# UNITED STATES PATENT AND TRADEMARK OFFICE

APPLICATION NO.	FILING DATE	FIRST NAMED INVENTOR	ATTORNEY DOCKET NO.	CONFIRMATION NO.
10/627,262	07/25/2003	Hakan P.O. Larsson	03370-P0047A	7595

## Office Action Summary

### **DETAILED ACTION**

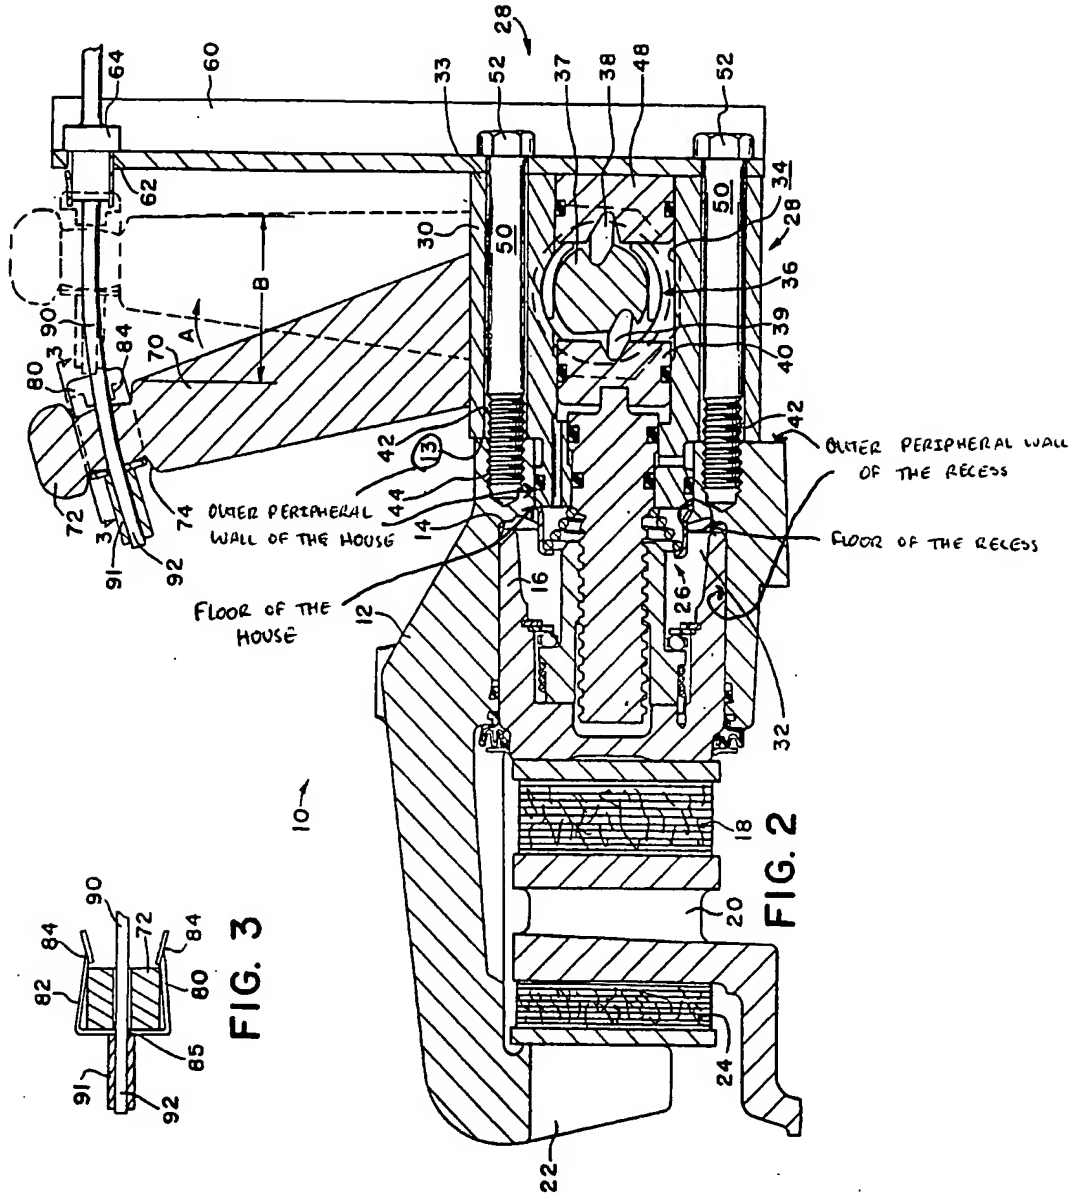
Re-claims 1 and 13, Smith et al. disclose a modular disc brake, comprising: a service brake mechanism 36 having at least one thrust unit (brake 36 is capable of acting as a service brake) and modules in the form of a frame 12, a cover 60, and a house 30 for the service brake, a part of the house is positioned between and outside the frame and the cover and mounted to be substantially unloaded during braking, see column 3 lines 18-24; the frame includes a recess defined by an outer peripheral wall (either the surface adjacent 13 or the interior surface of the

recess, which can be broadly interpreted as an outer peripheral wall with respect to the central hole volume) and a floor (the flange portion the extends inwardly from the interior surface the recess, see attached figure), the floor has a hole for the thrust unit; the house comprises an outer peripheral wall (either 13 or the outer surface of the inserted portion of the house in the recess) and a floor (the base of the inserted portion of the house that is in the recess), the floor has a hole for the thrust unit; the outer peripheral wall of the house corresponds in size and shape to the outer peripheral wall of the recess, the house is disposed in the recess in the frame such that the floor of the house abuts the floor of the recess, the holes of the recess and the house are aligned and allow the thrust unit to pass therethrough.
